Model: Bellini-C3 Finisher(VICTORIA-E)		Date: 23-Feb-07	No.: MB830001
Modified Article: PCB Main Control		Prepared by: S. Ishizu	
From: 2nd Tech. Support Sec. Service Support Dept.			
Reason for Modification:	☐ Parts catalog correction ☐ Vendor change ☒ Other ☐ To facilitate assembly ☐ To improve reliability ☐ To meet standards ☐ Part standardization ☐ Product Safety ()

MODEL NAME	CODE	SERIAL NO.
Finisher SR5000	B830-17	L5870400052
	B830-26	9Z70470001

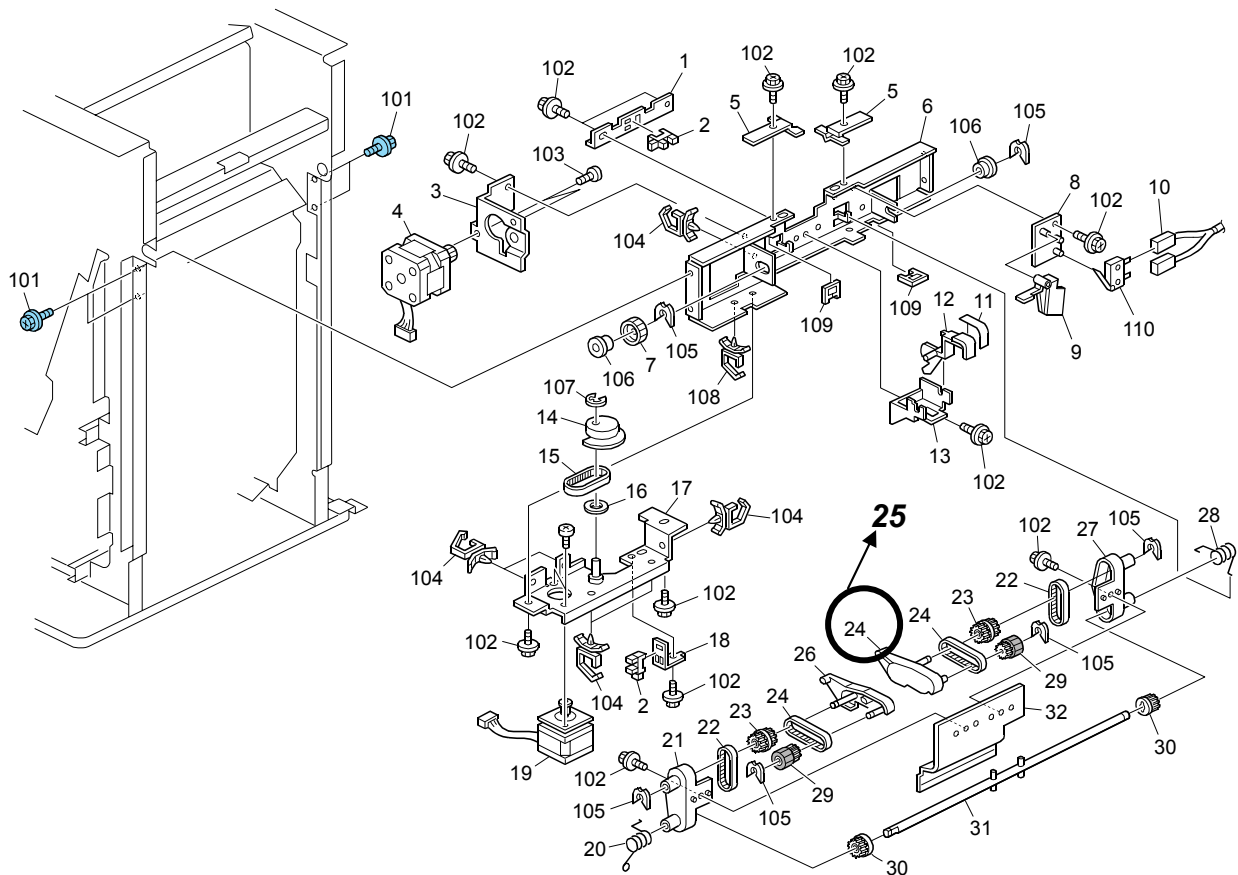
Change: The shape of the shift tray was changed.

Reason: To further strengthen the shift tray.

16.PAPER EXIT SECTION 1 (B830)

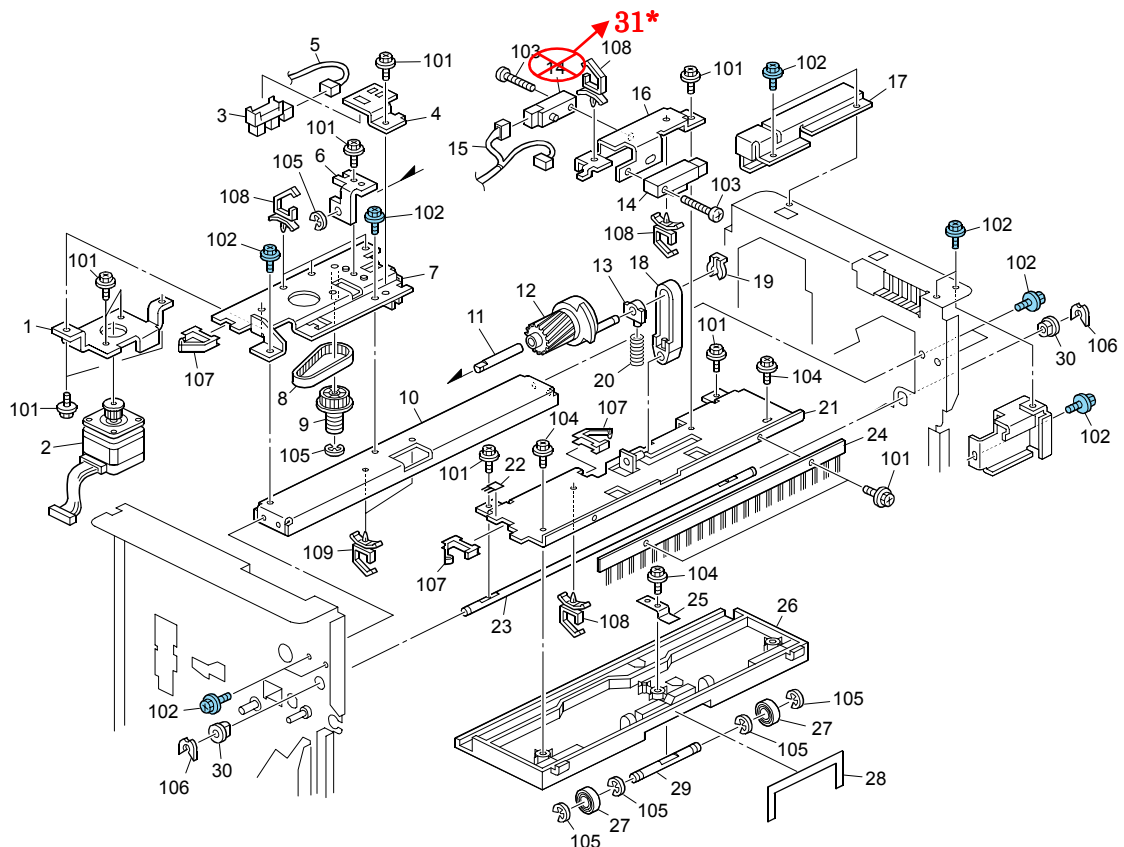
New P/N added to the Parts catalog.

New P/N	Description	Q'ty	Page	Index	Note
AW010109	Photo Reflection Sensor	1	37	31*	*: New Index

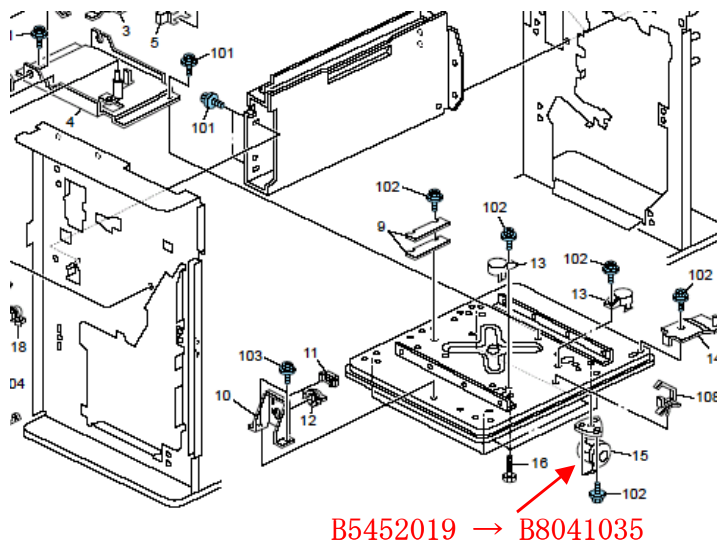
Change: 4 casters will be exchanged with new parts.

Reason: To reduce costs by using lower price components.

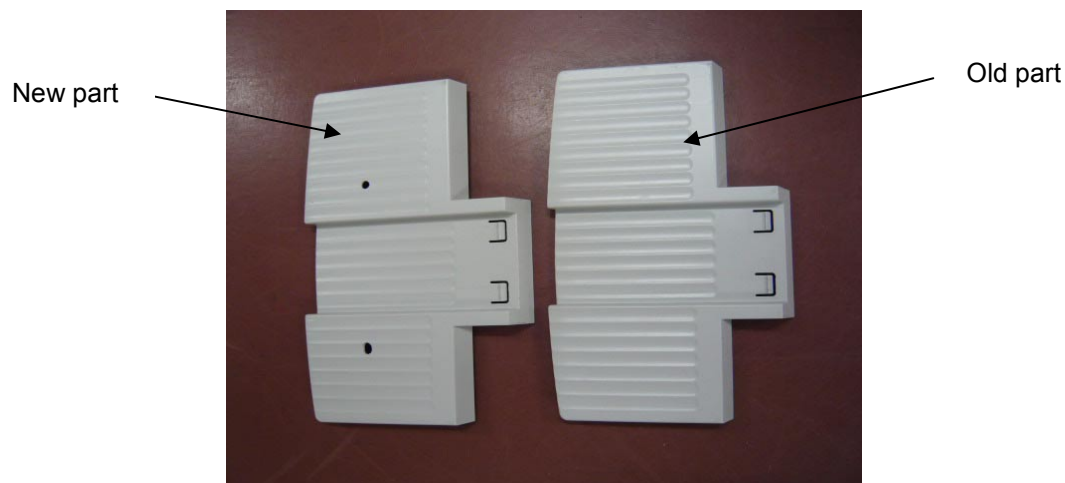
CHANGE: Holes were added.

REASON: To prevent coated paper from dashing out when Aegis is connected.
